## SERVICE BULLETIN

**BULLETIN NO:** 14-007

**TITLE:** Integral Spindle Mounting Bolts

**PRODUCT SERIES / MODEL:** HR1500 Series B2, HR1500 Series B3 and HR1500 Series C1  
HY-RAIL® Guide Wheel Units

FIGURE 1  
INTEGRAL SPINDLE AND STUB AXLE ASSEMBLY

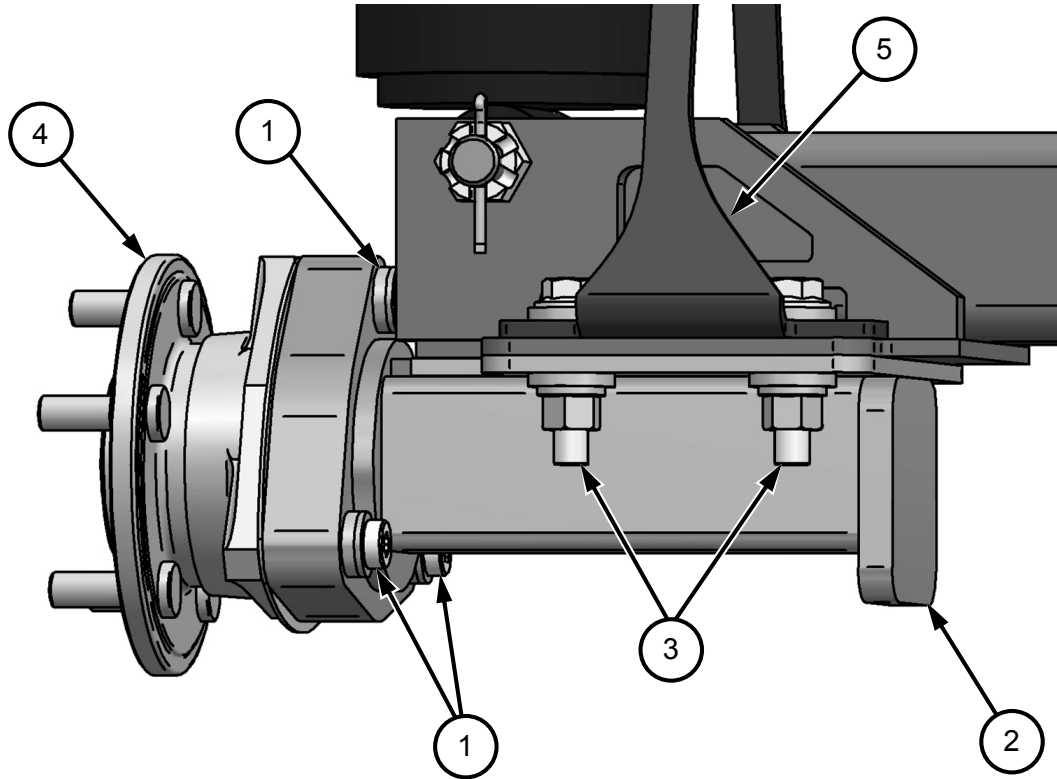
**OPERATIONAL IMPACT:** Integral spindle mounting bolts could become loose and / or break if improper repair procedures are used when the integral spindle is replaced on the guide wheel unit. Failure of the integral spindle mounting bolts may result in the loss of the guide wheel.

2. To be able to remove and re-install the three M12 socket head cap screws (1) properly, the stub axle (2) will need to be removed from the guide wheel unit.

3. Remove the four 1/2"-20 disc lock nuts, washers and hex head cap screws (3) to remove the stub axle (2). Place the stub axle in a vice to hold it securely.

4. Remove the three M12 socket head cap screws, washers and insulating washers (1) being careful not to damage the insulating bushings inside the mounting holes. Remove integral spindle (4) from stub axle (2).

7. Apply Blue Loctite 242 to the threads on the three M12 socket head cap screws (1). Install the integral spindle on the stub axle.
8. Secure the integral spindle to the stub axle with the three M12 socket head cap screws. Make sure the M12 hardened washers and insulating washer are properly in place between the M12 socket head cap screws and the flange on the stub axle. Torque the M12 socket head cap screws (1) to 60 lb-ft (81 N-m).

9. Assemble the stub axle and axle strap (5) (if present) to the guide wheel unit using the four 1/2"-20 disc lock nuts, washers and hex head cap screws (3). Position the stub axle as close as possible to its original position when it was removed.

10. Torque the four 1/2"-20 disc lock nuts to 110 lb-ft (149 N-m).
11. Re-align the guide wheel equipment on the vehicle before returning the vehicle to service.

FIGURE 2  
M12 CAP SCREW, HARDENED WASHER  
AND INSULATING WASHER ASSEMBLY DETAIL

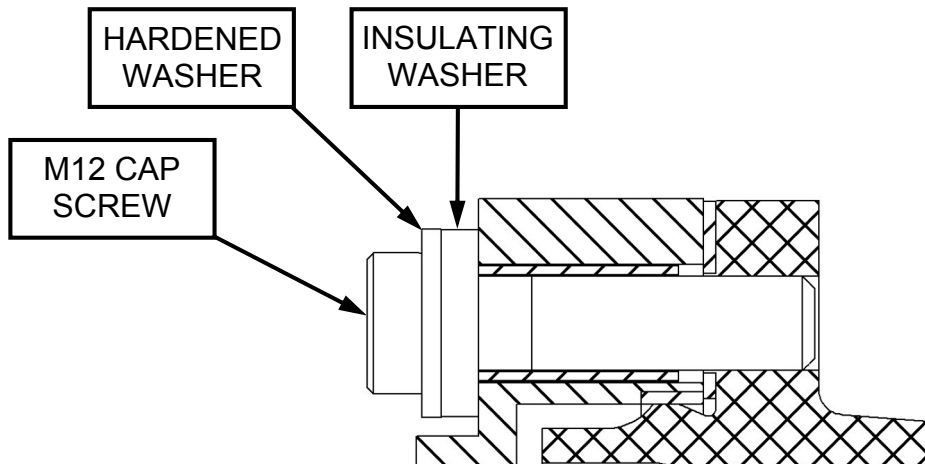
5. Clean the threaded holes in the integral spindle and the threads on the three M12 socket head cap screws.
6. Inspect all insulating washers and bushings. If any are found that are damaged, replace them.
